**CALIFORNIA COASTAL COMMISSION**

REGULAR CALENDAR  
STAFF REPORT AND PRELIMINARY RECOMMENDATION

Application No.: 6-99-43

Description: Subdivision of approximately 7.8 acres of vacant land into 20 lots and construction of 42, two-story, three-bedroom condominium units, with associated private interior streets and driveways, utility connections, landscaping, private gated entry and a public trail on the north shore of Agua Hedionda Lagoon. Also proposed are off-site improvements to Bayshore and Marina Drives and enhancement of existing wetlands on-site.

EXHIBIT NO. 3  
Application No. 6-99-43  
**Site Revision**  
**Submitted 4/24/00**

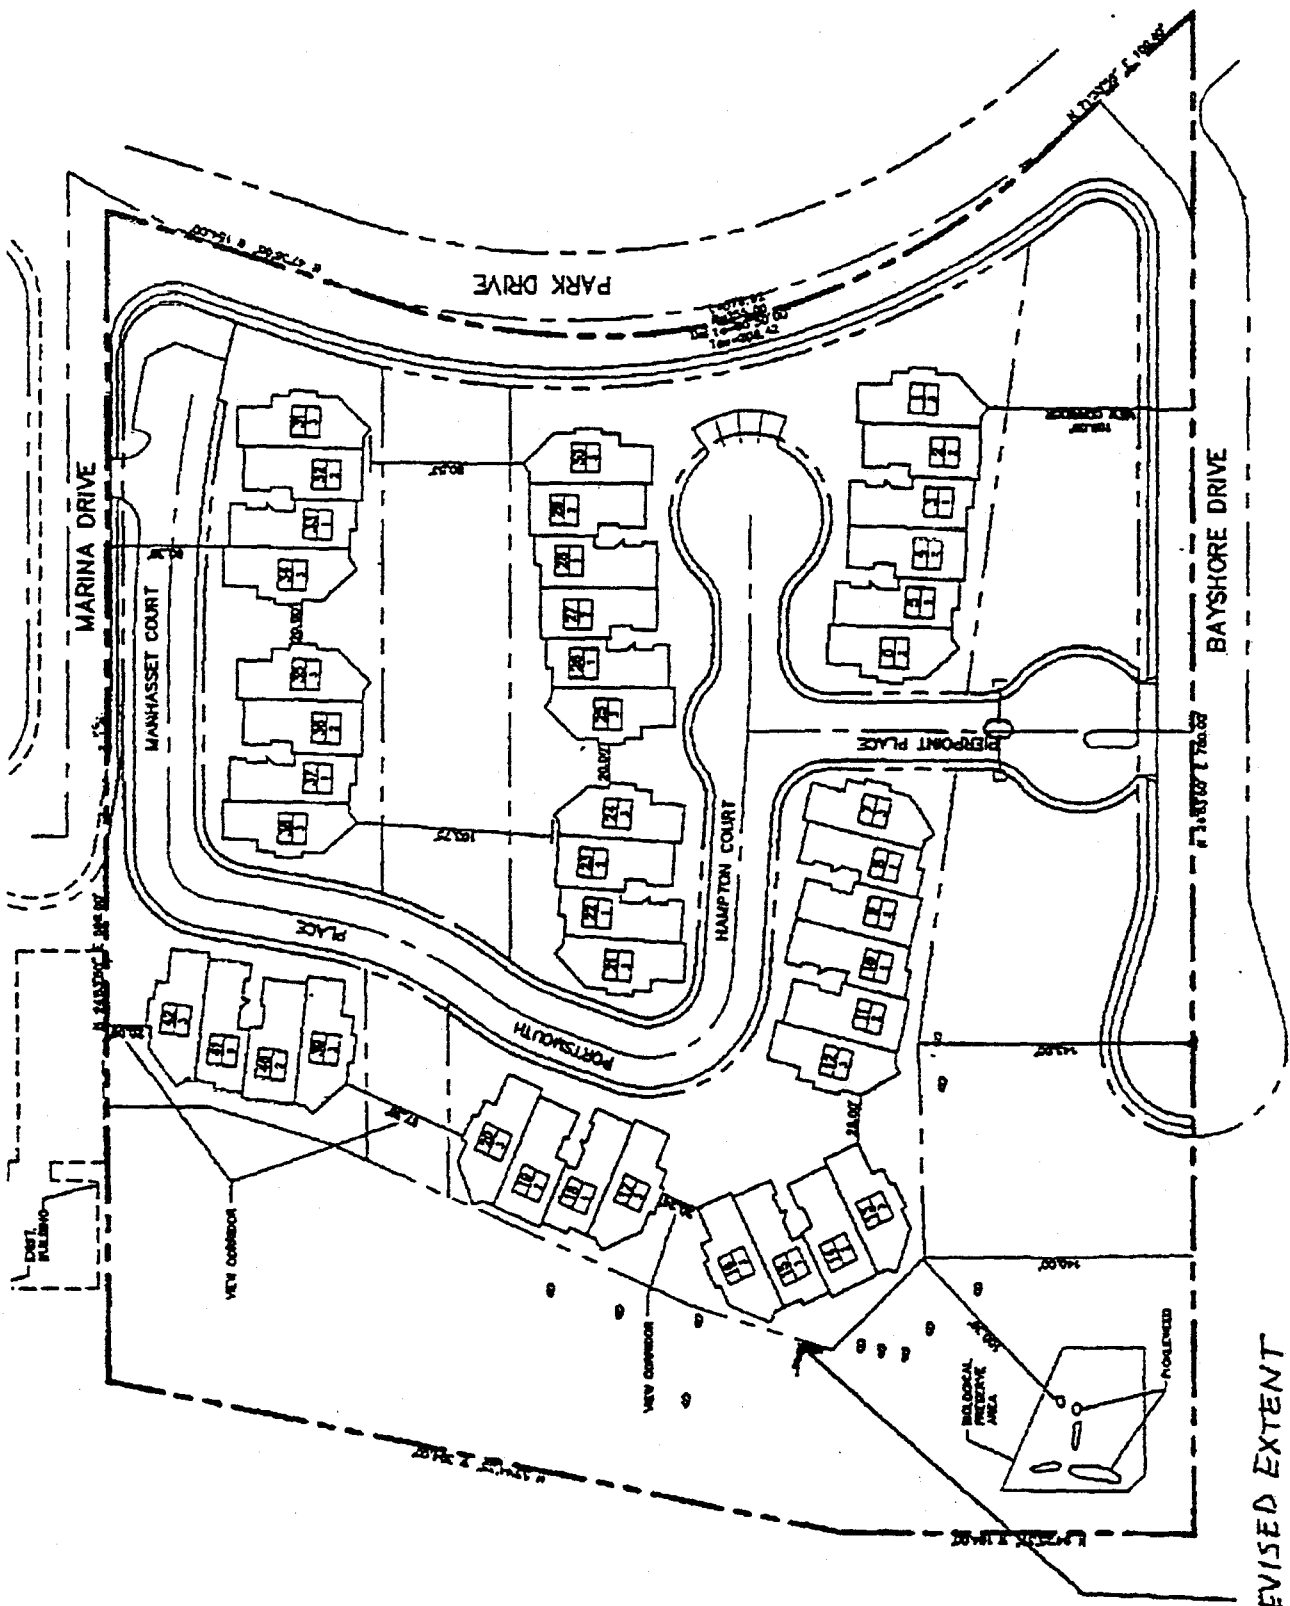
1990. The applicant initially submitted plans in conformance with the tentative map (i.e., resubmitted the 1990 plans). The applicant subsequently revised the submitted site plan to include an increased building setback from the existing on-site wetland vegetation to 100 feet. The applicant asserts that the project with this change is still in substantial conformance with the City approval. That plan is depicted in Exhibit #3.

EXHIBIT NO. <b>6</b>
APPLICATION NO. <b>6-99-43</b>
<b>Grading Plan</b>
<b>SE Portion</b>
California Coastal Commission

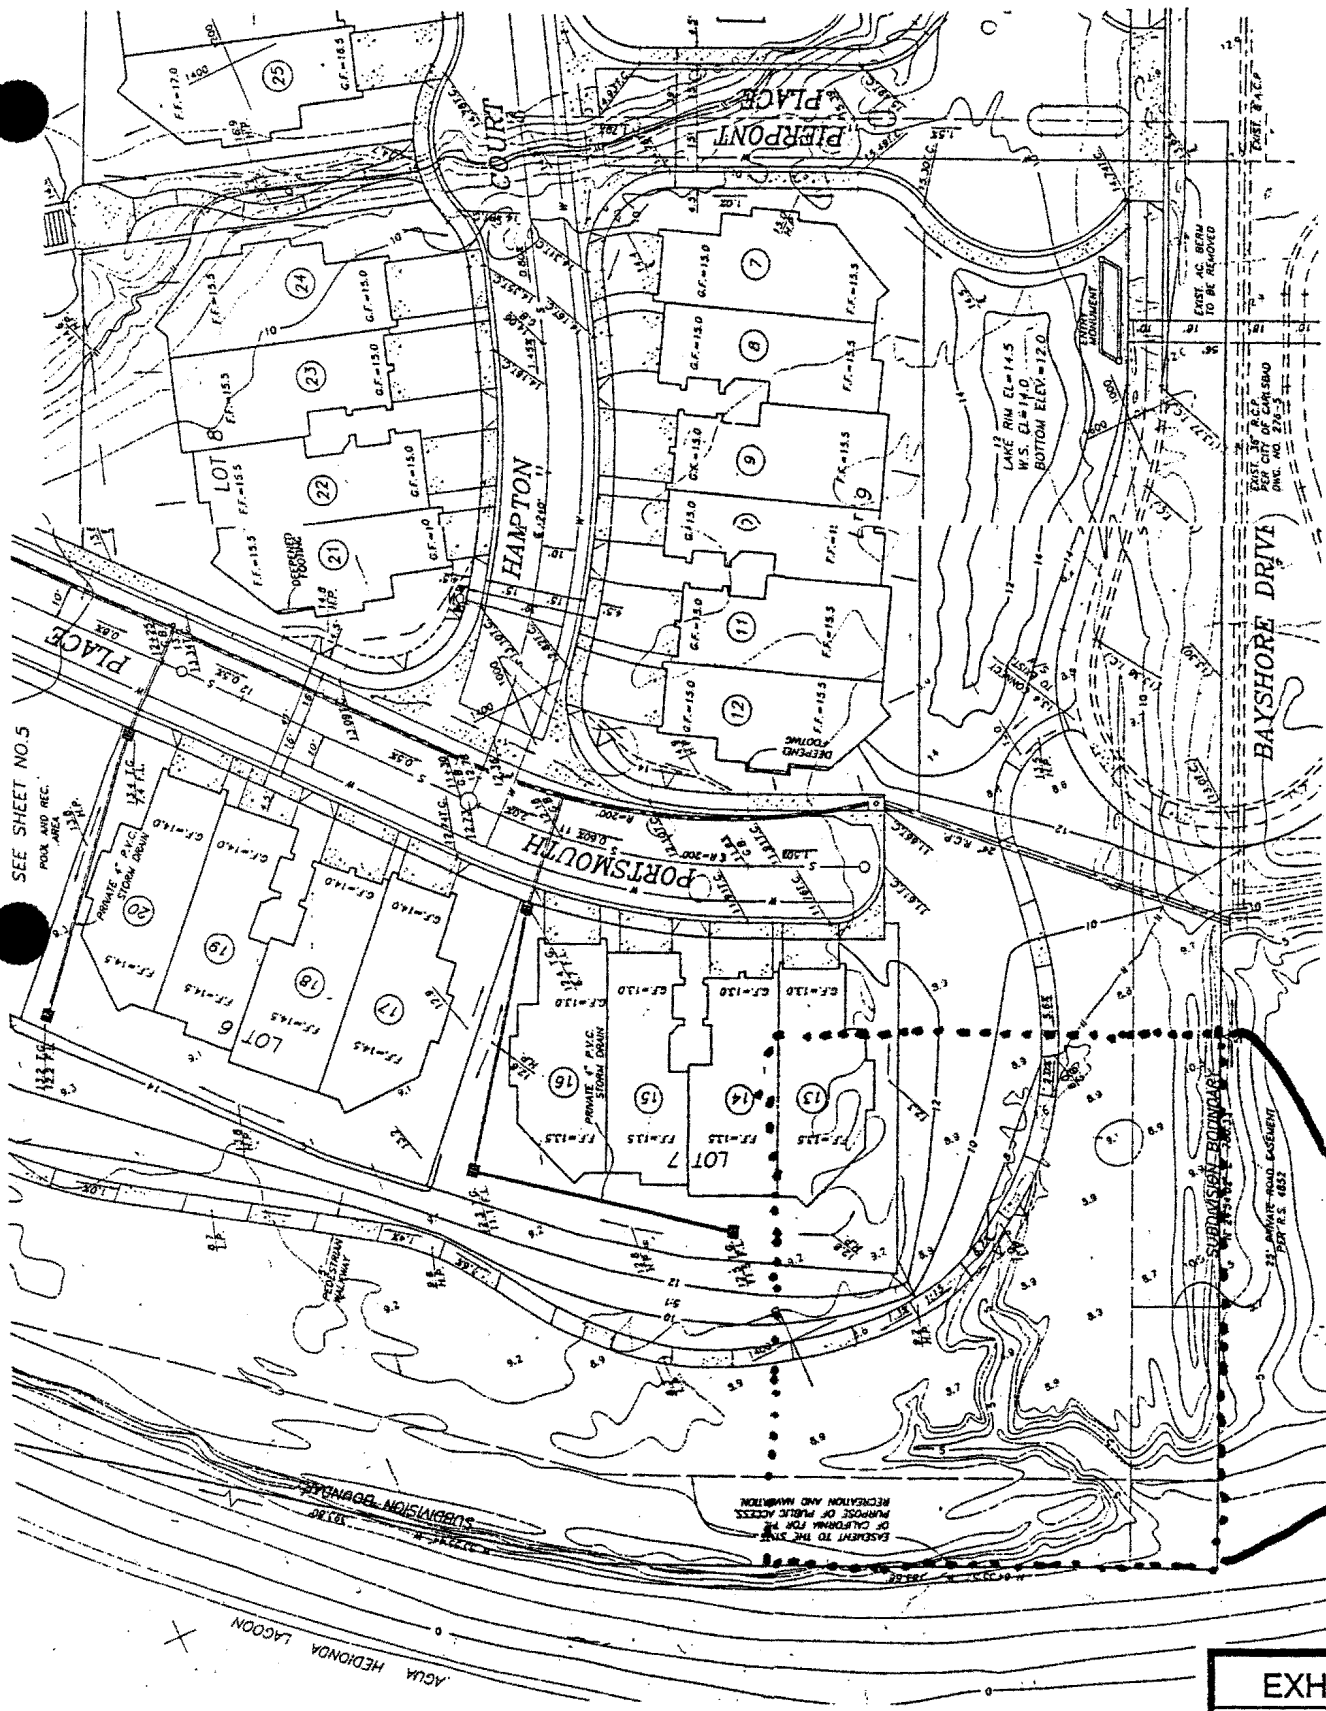
Thus, the wetlands issue raised by the project is whether the wetlands in the erosional feature are protected as required by Sections 30233 and 30240 of the Coastal Act. The grading plans identified as *Preload Grading Plans* signed off by the project engineer on September 6, 1990, which were submitted with the application, indicate that site grading would occur within fifty feet of what was described as a "biological preserve area" (see Exhibit #3), which includes the salt marsh vegetation identified in 1990 and about two-thirds of the surrounding erosional feature. Moreover, additional grading plans identified as *Grading Plans for The Hamptons* (CEPA Planning, Surveying, Engineering), which are not signed or dated but carry the same engineering stamp as the other grading plans, were submitted with the application on March 26, 1999 and again on August 6, 1999. These plans show grading and construction of the proposed public access path within the erosional feature itself and are included as Exhibits #6 and #7, which show the general area of the site and a close-up of the erosional feature, respectively. The existing wetland vegetation is not depicted on that grading plan. Thus, it is unclear whether the proposed grading would involve fill within the existing nearly 400 sq.ft. of wetland vegetation, shown as five separate patches on Exhibit #3. However, as stated above, the entire erosional feature may well meet the definition of wetlands. If the erosional feature does consist entirely of wetlands, the proposed grading would involve fill of wetlands.

**THE HAMPTONS**  
**TRACT 89-13**  
**CARLSBAD, CALIFORNIA**  
**VIEW CORRIDOR/SETBACK PLAN**

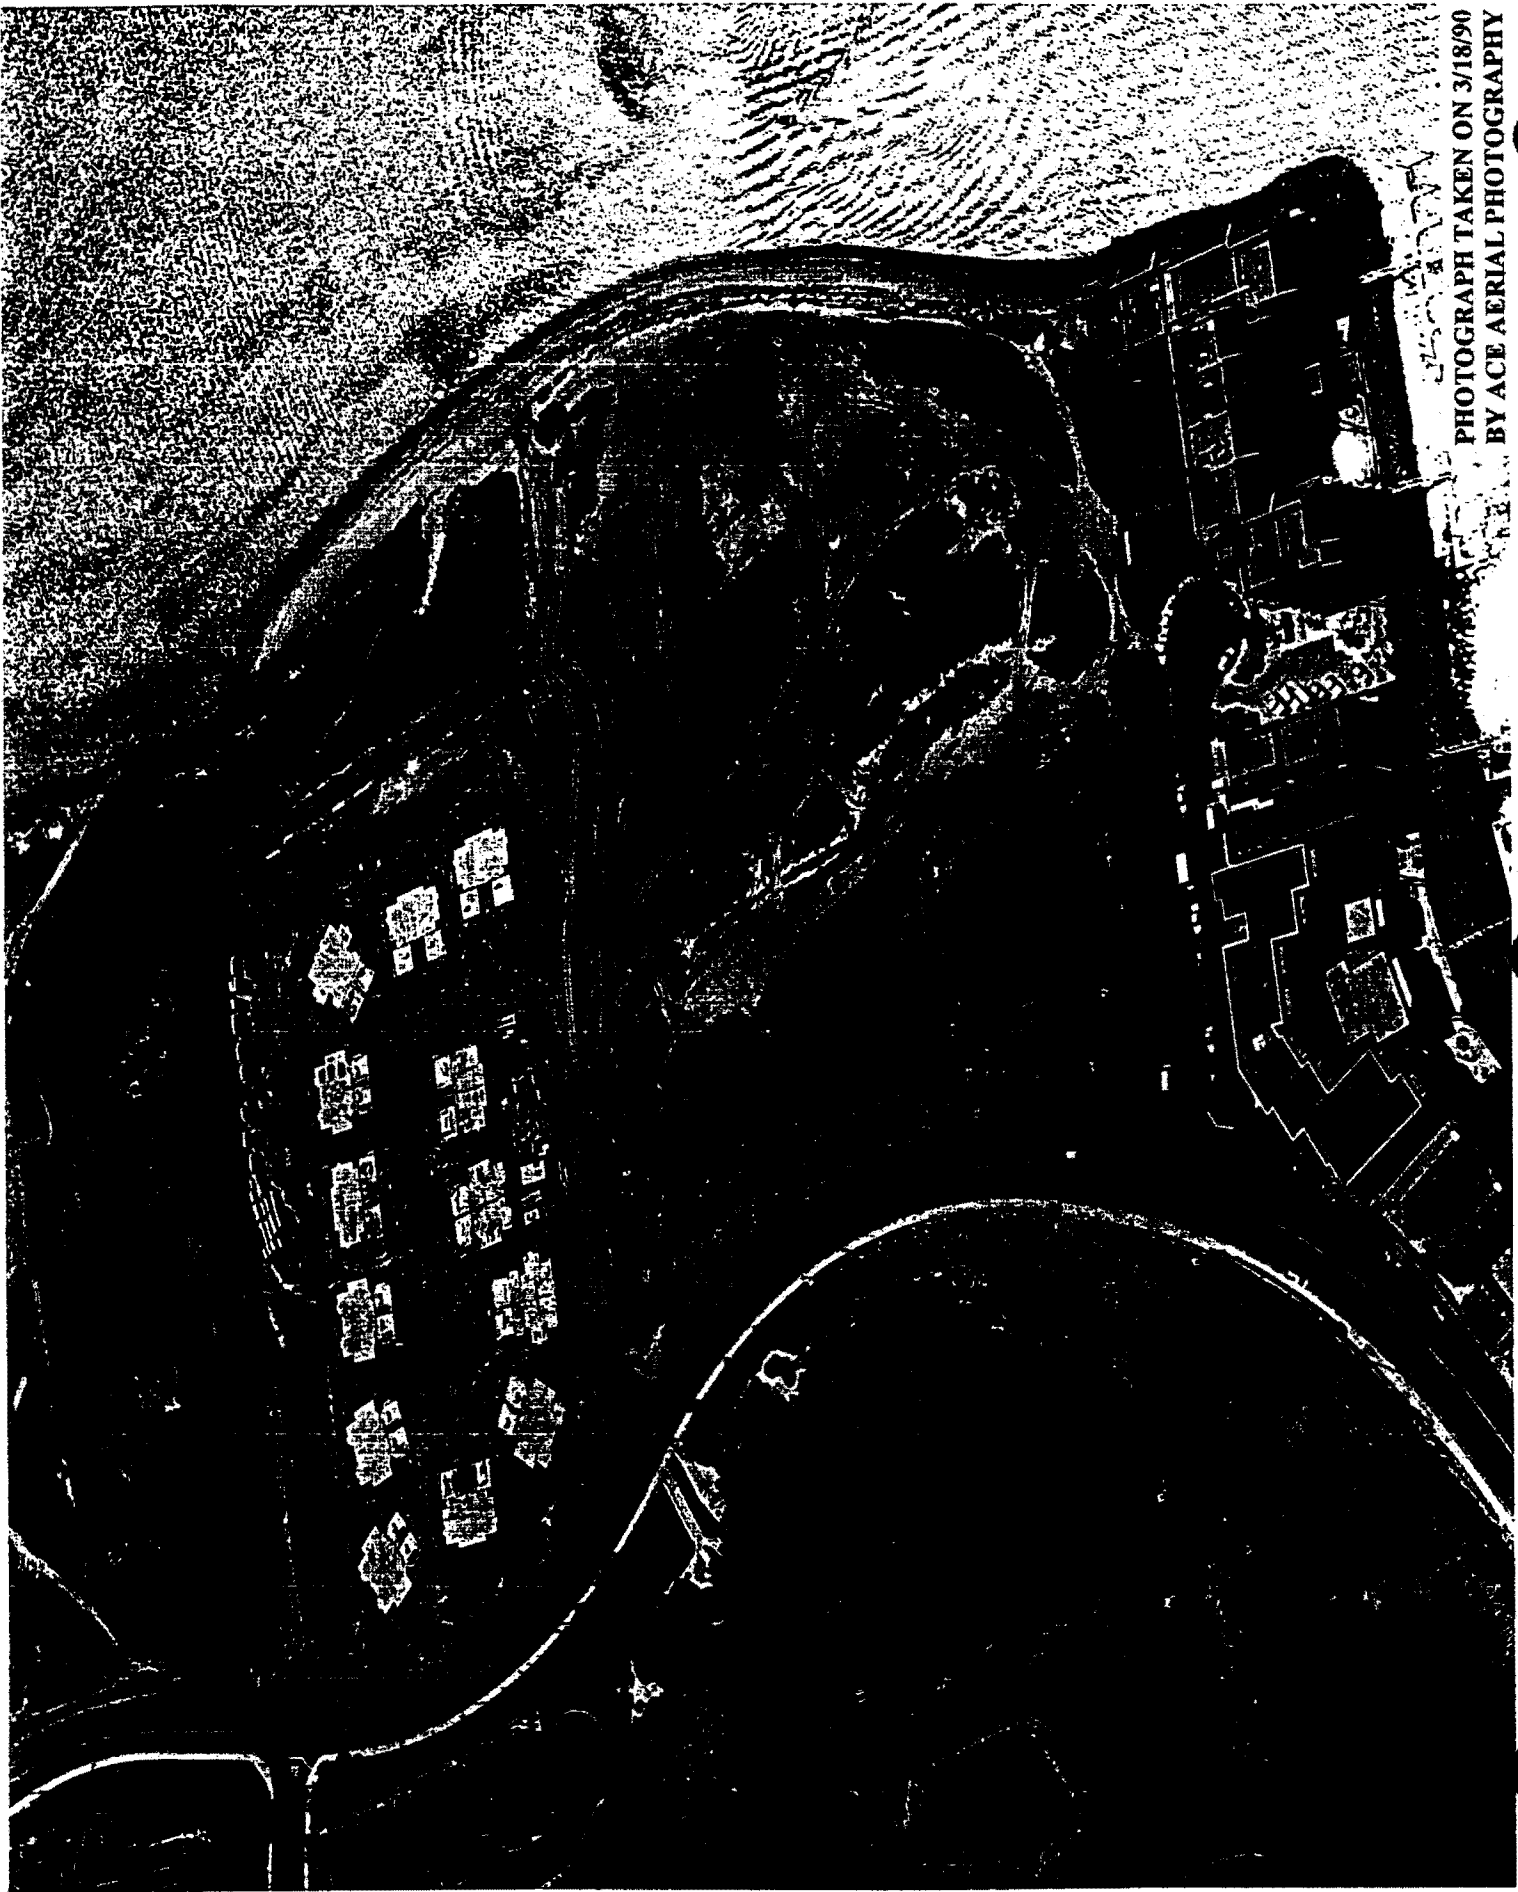
Attached hereto as Exhibit A is a site plan for the Property which show the impacts each of the respective recommended special conditions of approval impose upon development of the Project. Combining the buffer zone setback for the erosional feature wetland, the public street widening requirement, the City of Carlsbad 20 foot setback limits, the Agua Hedionda setback limits, and the view corridor requirements, it is all too clear that there is little left for development.
